ADDENDUM

TO: All Concerned	ADDENDUM No.:	One (1)
RE: Admin Roof Replacement Rend Lake College	DATE OF ISSUE:	March 5, 2018
FOR: Illinois Community College District #521	DOCUMENT DATE:	February 16, 2018
	PROJECT No.:	1749

Project No.: 1749	Project Title: ADMIN ROOF REPLACEMENT	 EGGEMEYER ASSOCIATES ARCHITECTS 3029 South Park Ave. P.O. Box 640 Herrin, IL 62948 IDPR 184-000255 T 618.988.2380 F 618.988.2381 eggemeyer-architects.com	Sheet No.:
Date: 3/5/18	For The: REND LAKE COLLEGE		AD-1
Drawn By: EJK			Of: 1
Checked:

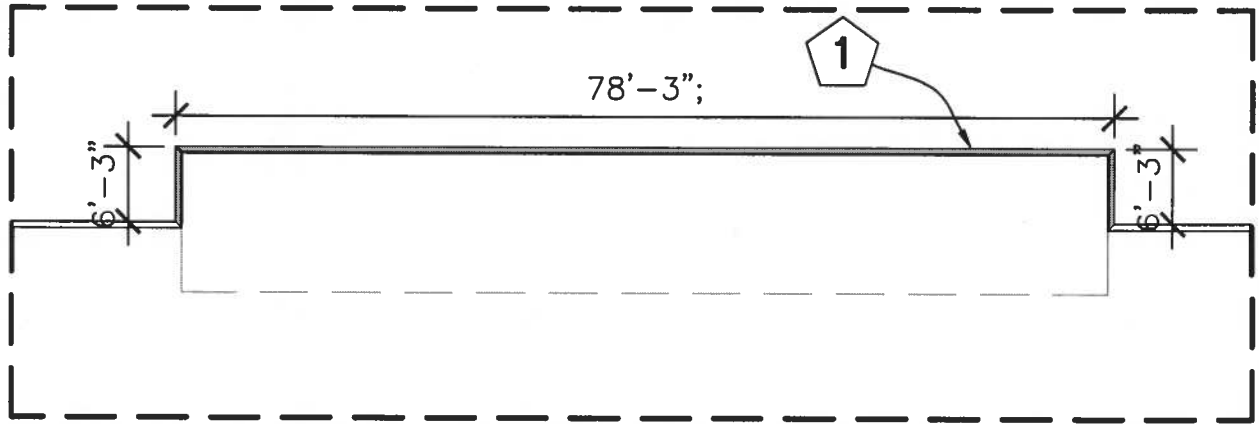
ITEM 5: Sheet A2-0: Partial Roof Plan – Academic Building.
Revise:

ITEM 6: Sheet A2-0: Partial Roof Plan – Gymnasium.
Revise:

Revise the length of gutter to be replaced from 121'-11" to 147'-0". Tie new canopy gutter into the building gutter with a smooth transition. See attached drawing AD-1

Revise the length of gutter to be replaced from 78'-3" to 91'-10". Tie new canopy gutter into the building gutter with a smooth transition. See attached Drawing AD-1
